| Illinois Tollway Base Sheet Revisions |

| Section M Base Sheet Drawings | |
| | Effective: 03-01-2025 |

VERSION: 2025-03 BASE SHEET: M-ITS-1000 SHEET: 1 OF 2

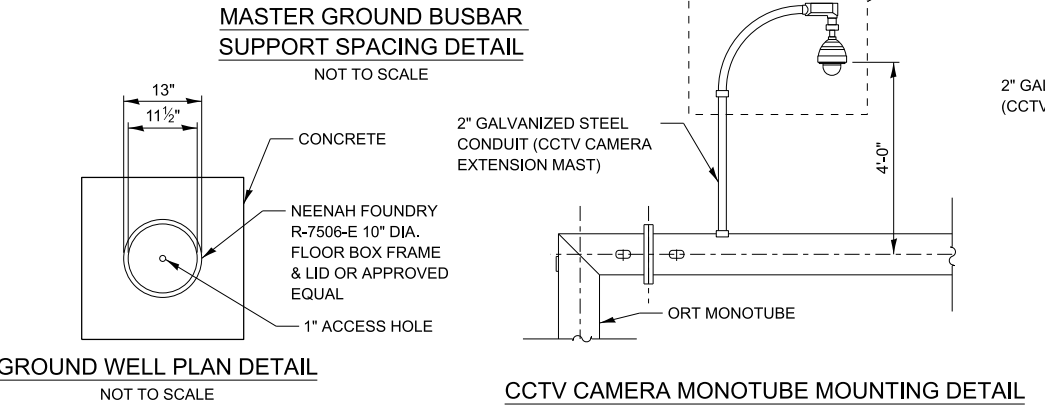
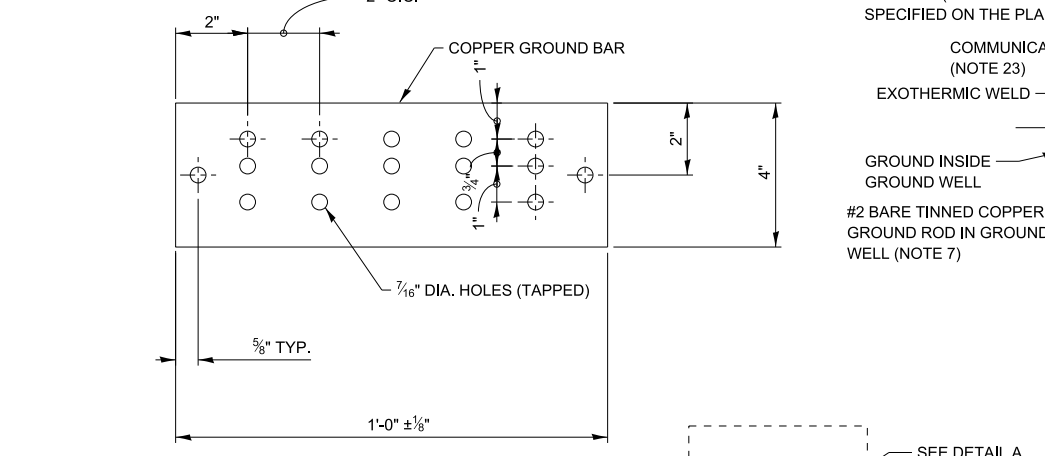
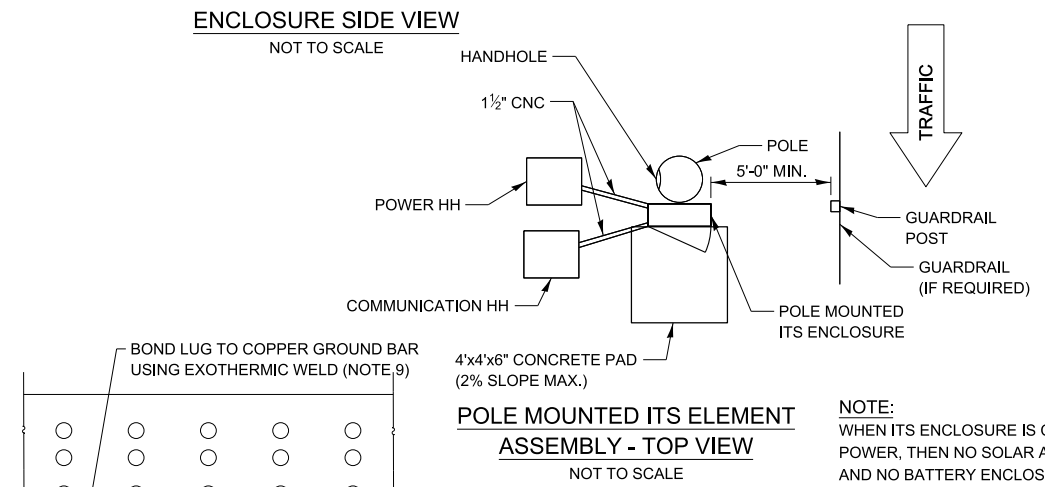
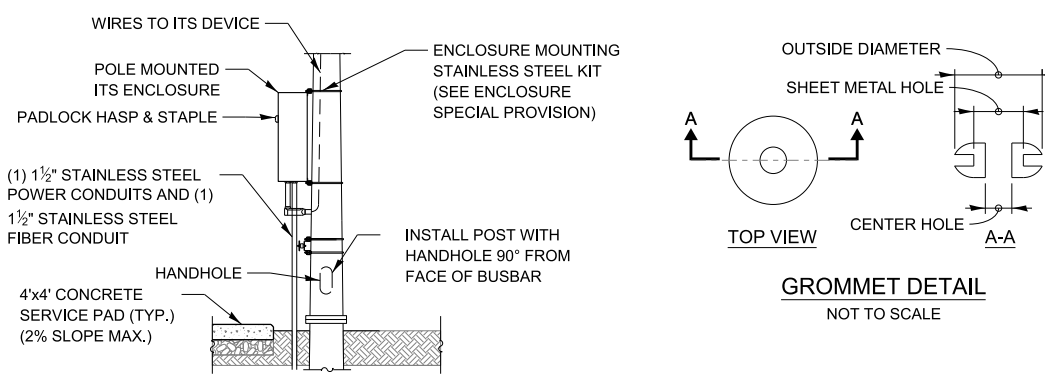
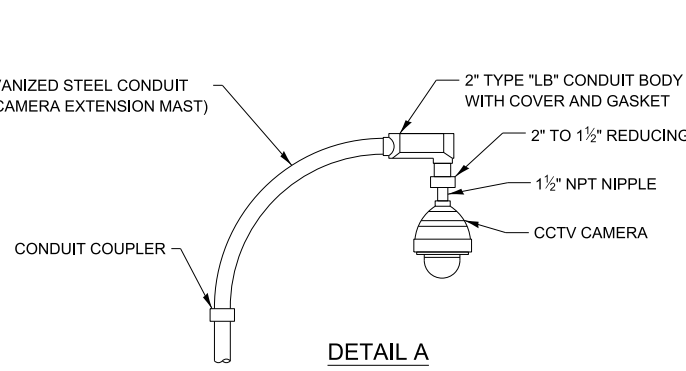
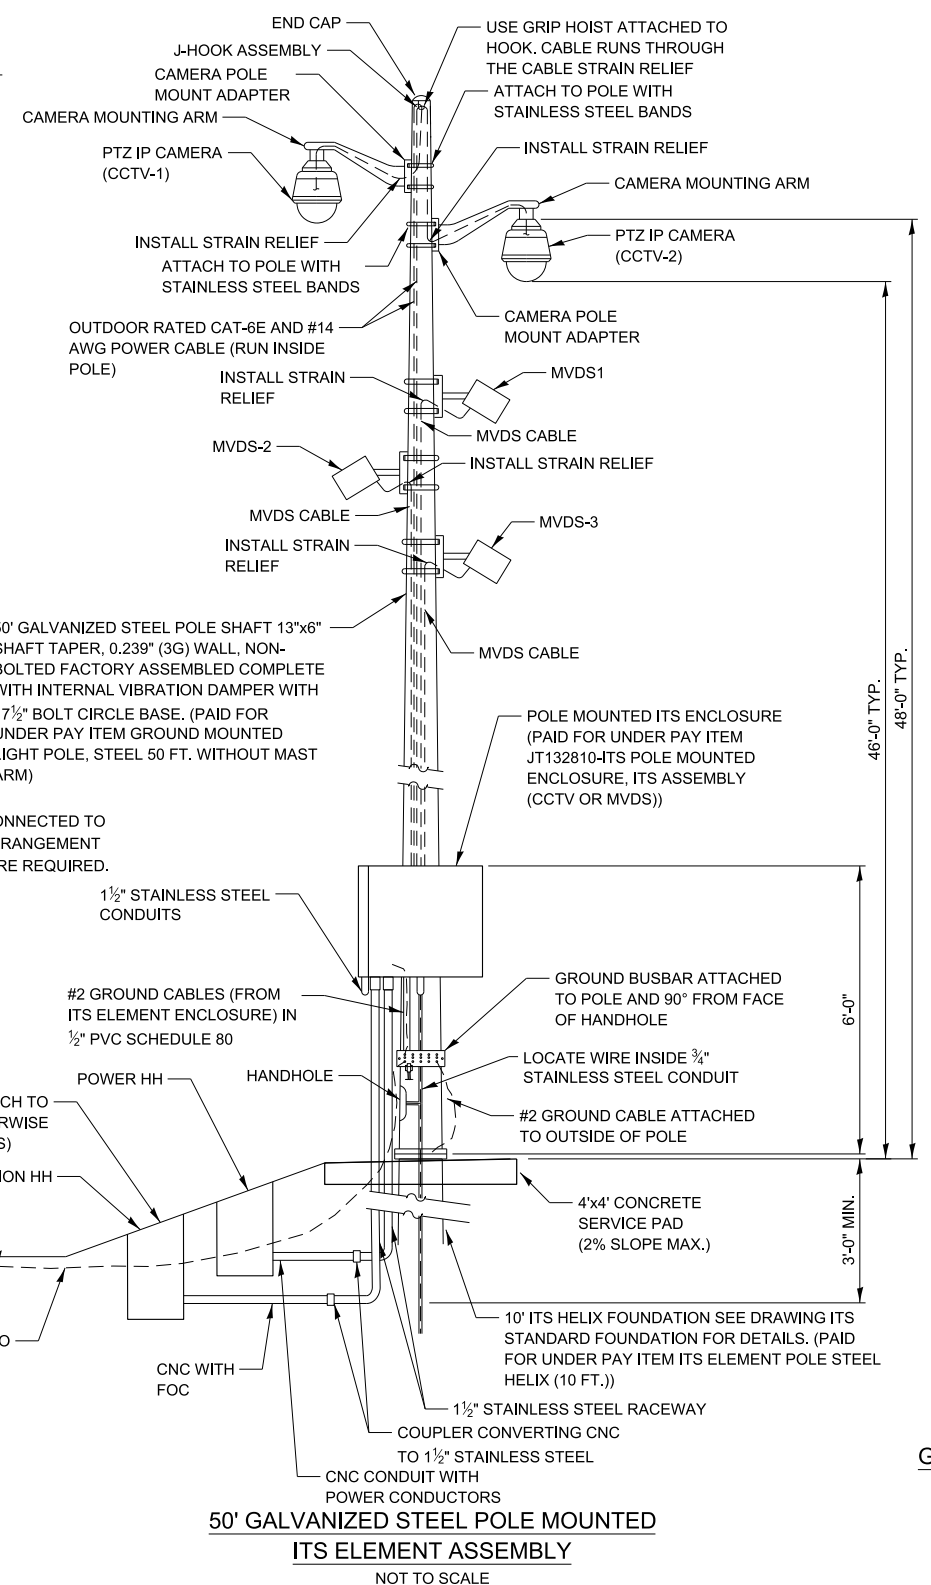
| Section M Base Sheet Drawings | |
|--|---|
| Sheet 1 | Added details for locate wire and conduit attached to the bottom of the ITS enclosure and showing connection to communication handhole |
| | Added option for pre-cast to the ground well details |
| | Remove reference to notes |
| | Replaced the name of "Schedule of Devices" to say: "Total Schedule of Devices" |
| | Removed "qty of solar panel on pole" from the Schedule of Devices table |
| | Removed "Solar Generator" from Schedule of Devices table |
| | Removed reference to M-ITS-1001 for notes |

| VERSION: 2025-03 | BASE SHEET: M-ITS-1003 | SHEET: 1 OF 2 |

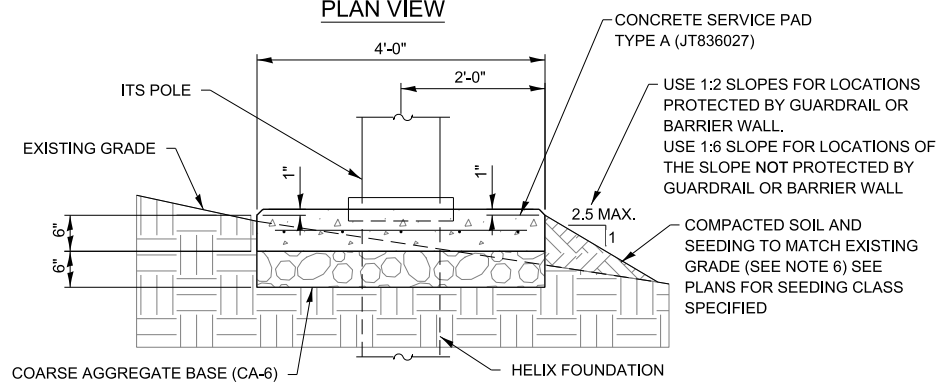
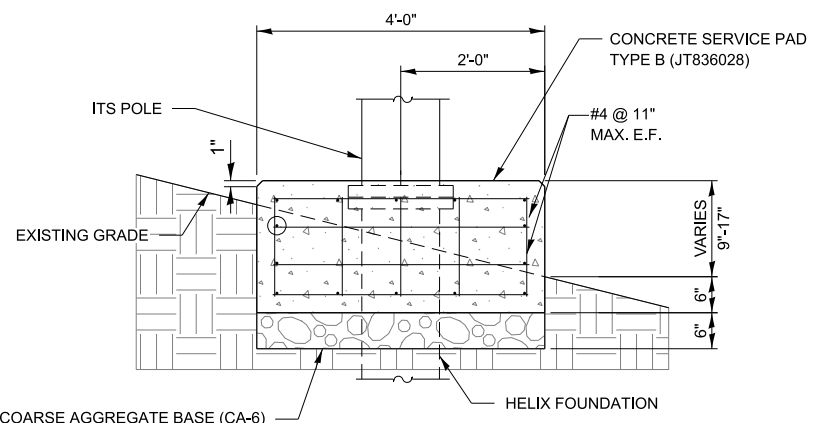
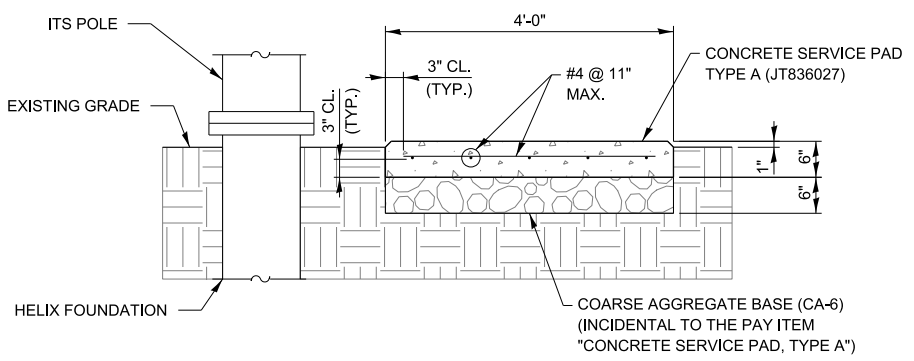
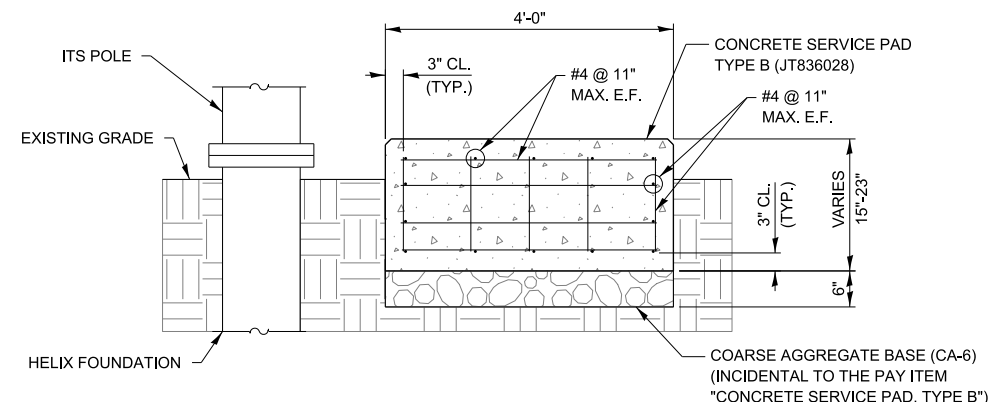
| Section M Base Sheet Drawings | |
|--|---|
| Sheet 1 | Added a note to say: "Cast in place or Pre-cast concrete pad" |

NOTE:
 CAST IN PLACE OR PRE-CAST CONCRETE SLAB

ITS CONCRETE SERVICE PAD

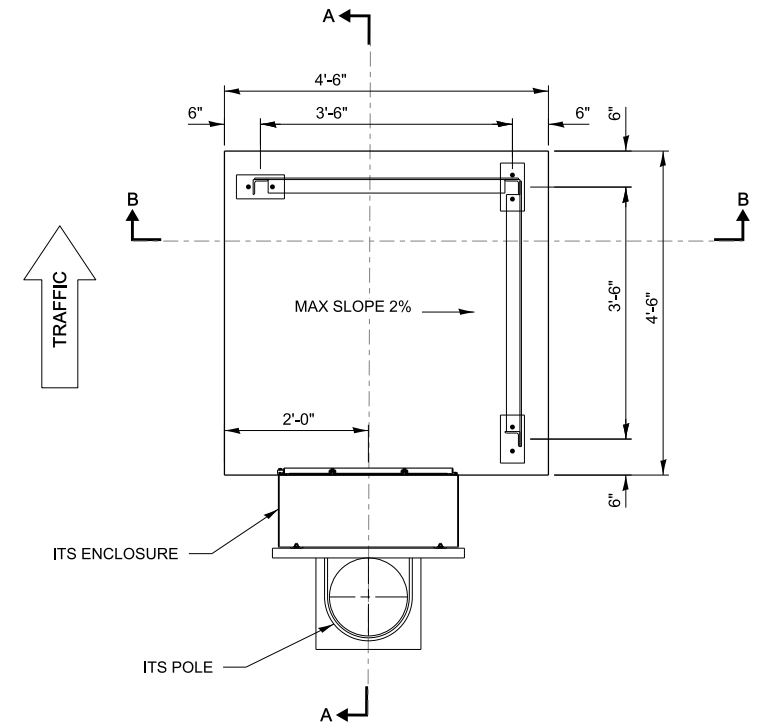
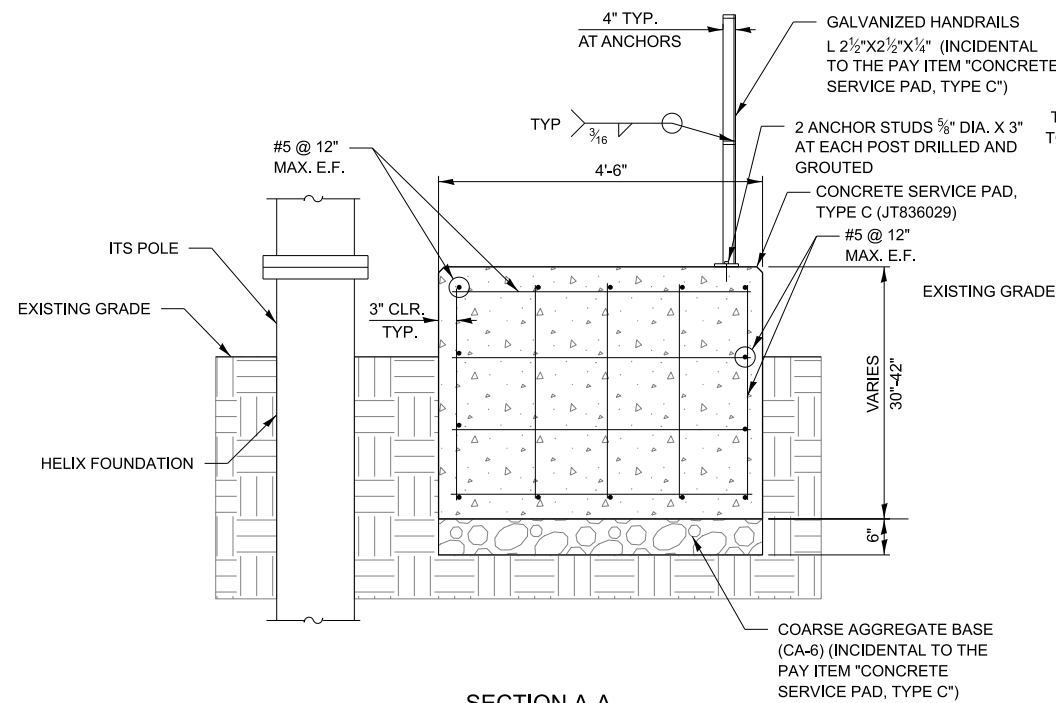
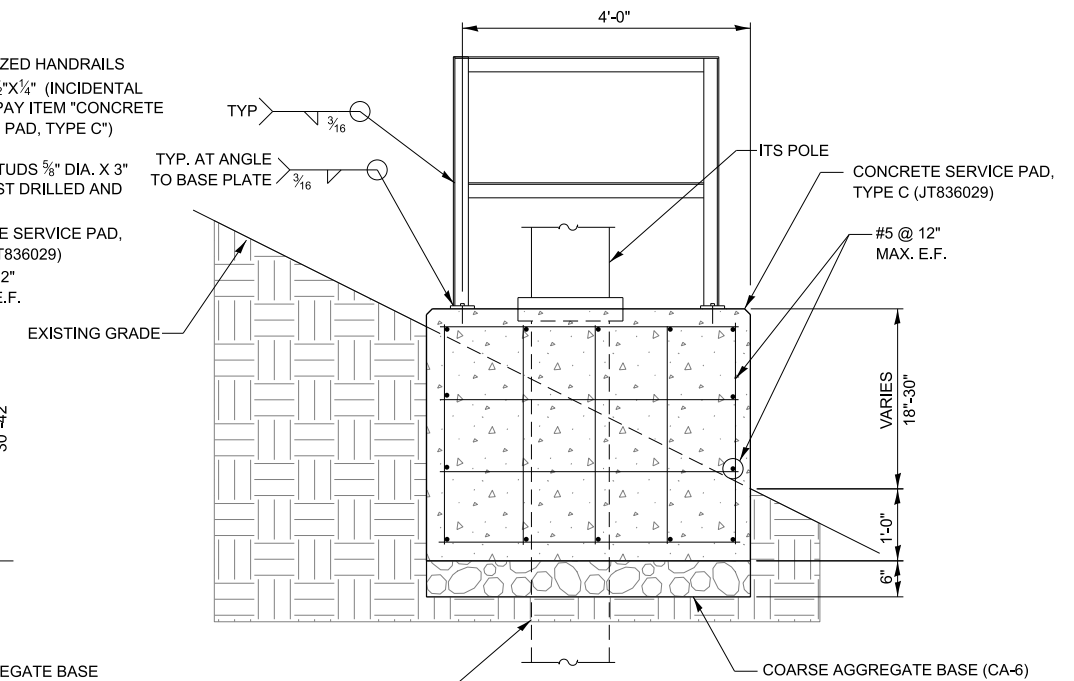
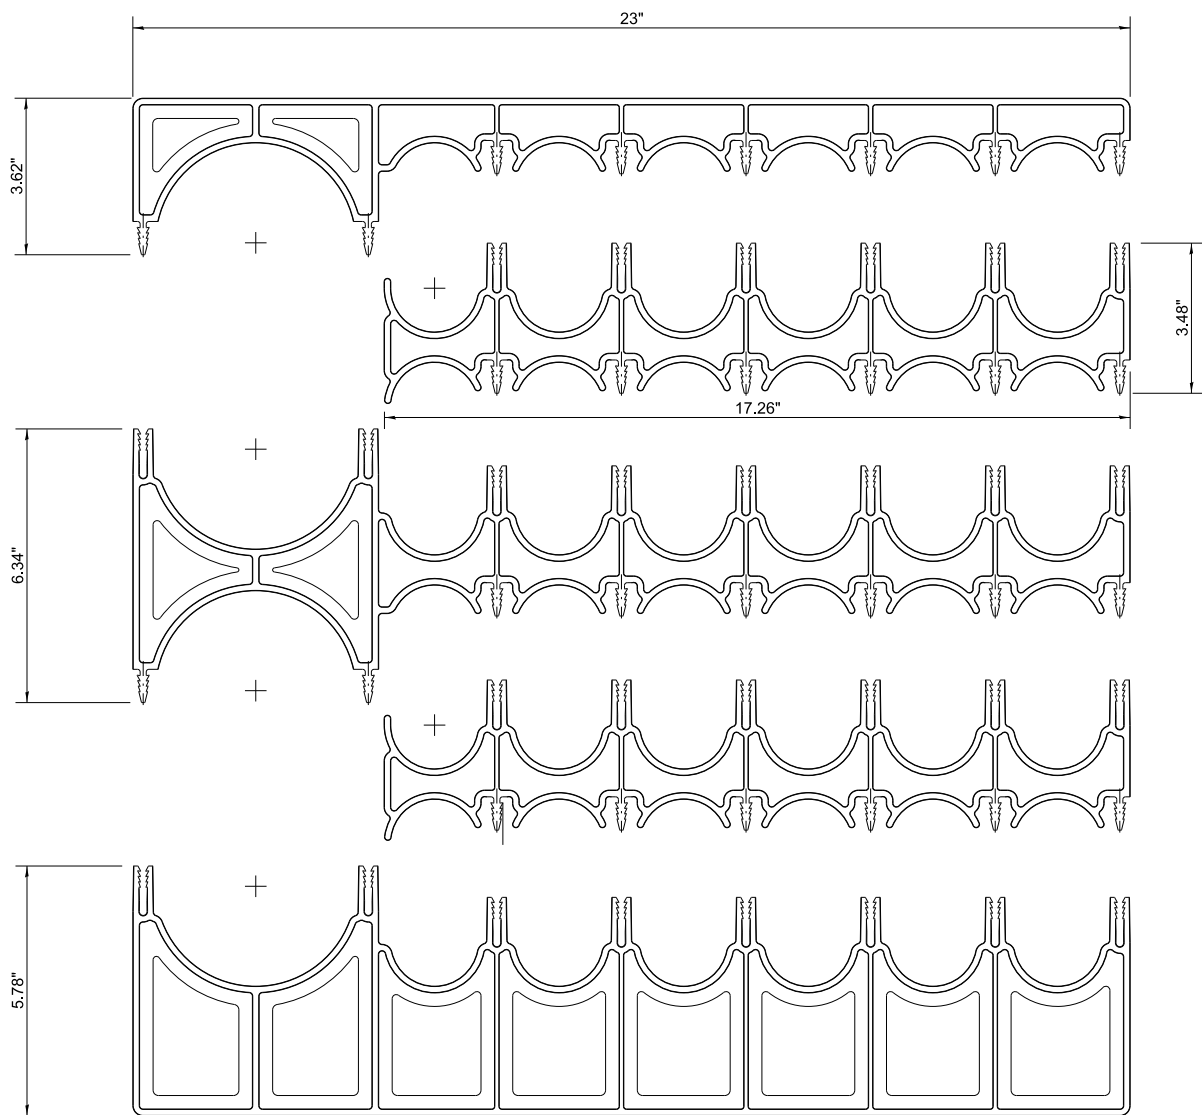
| Section M Base Sheet Drawings | |
|--|---|
| Sheet 2 | Added a note to say: "Cast in place" for the concrete service slab |

SPACER - DUCT PACKAGE IN A TRENCH

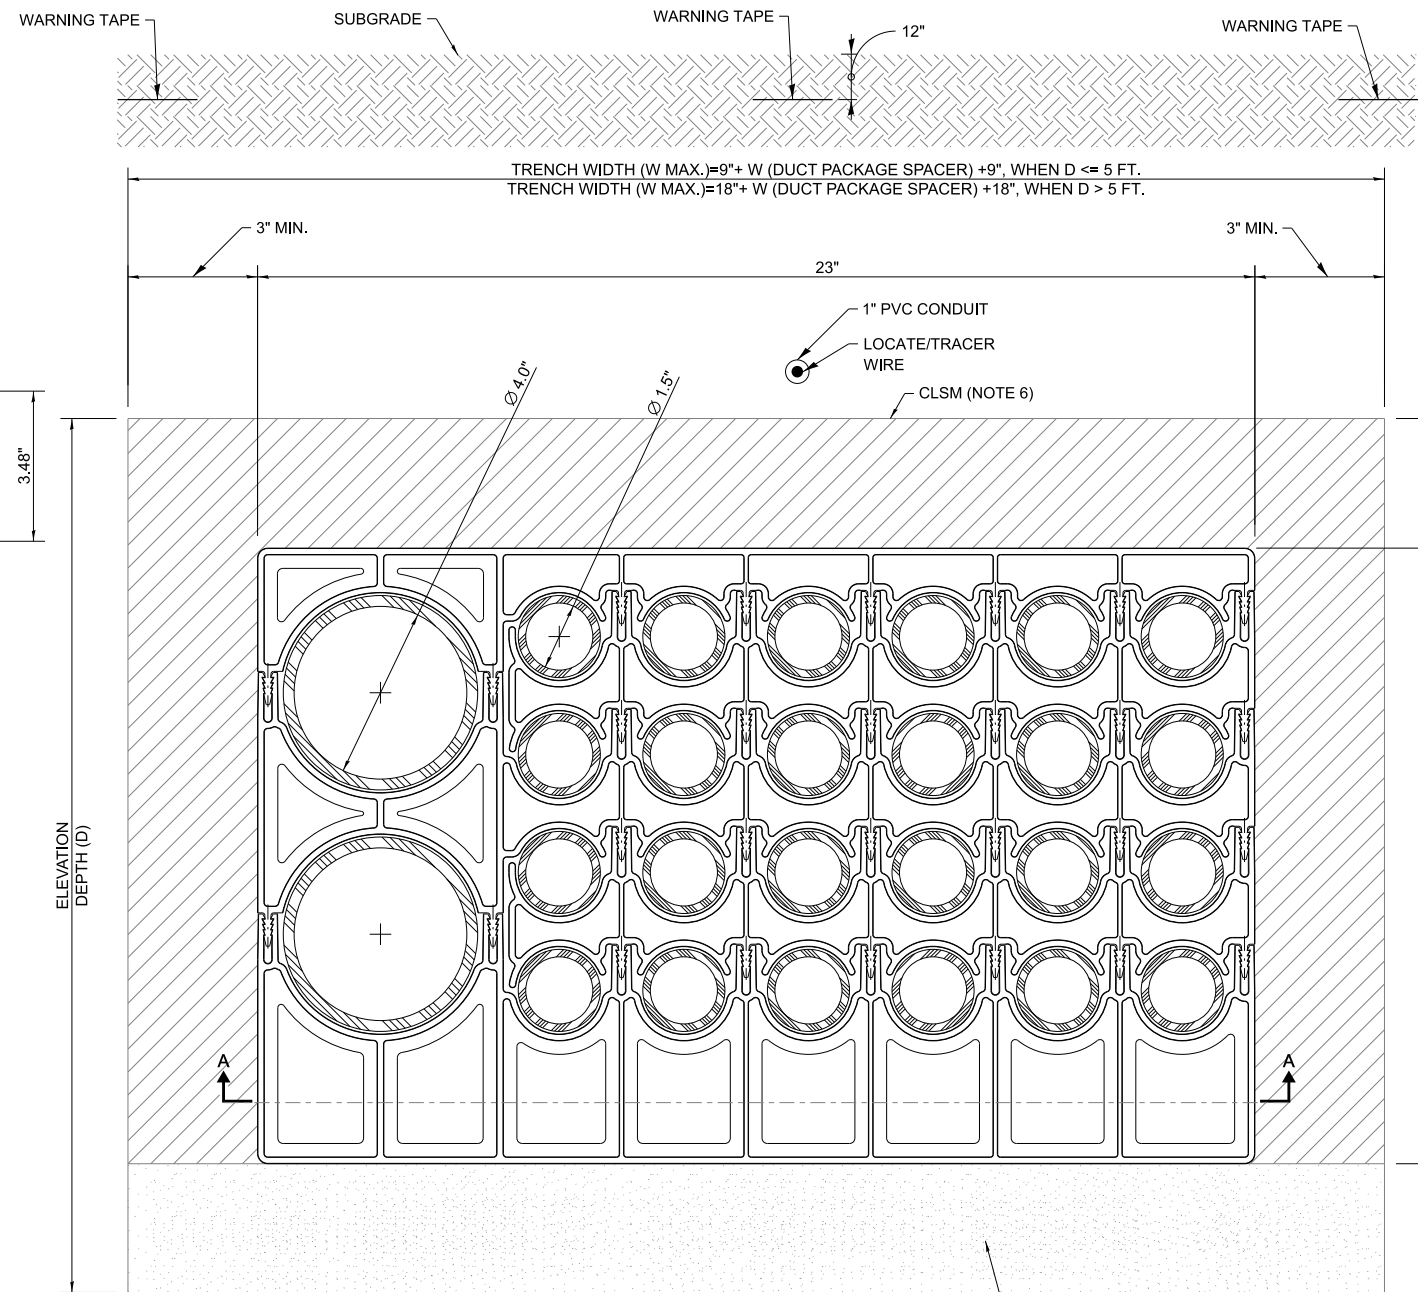
| Section M Base Sheet Drawings | |
|--|---|
| | Added two (2) warning tapes each at 12" deep one at center of the spacer and one at each end of the spacer |
| | Replaced Note 5 to say: The duct bank must be held in place at installed depth below subgrade during and immediately after the concrete pour to prevent conduit flotation |
| | Revised Note 6 to add: "... of the conduit assembly..." |

5. THE DUCT BANK MUST BE HELD IN PLACE AT INSTALLED DEPTH BELOW SUBGRADE DURING AND IMMEDIATELY AFTER THE CONCRETE POUR TO PREVENT CONDUIT FLOTATION.
6. CONTROLLED LOW STRENGTH MATERIAL (CLSM) SHALL BE PLACED A MINIMUM OF 3 INCHES ON EACH SIDE OF THE CONDUIT ASSEMBLY, AND ABOVE THE INTERLOCKING CONDUIT SPACER SYSTEM.
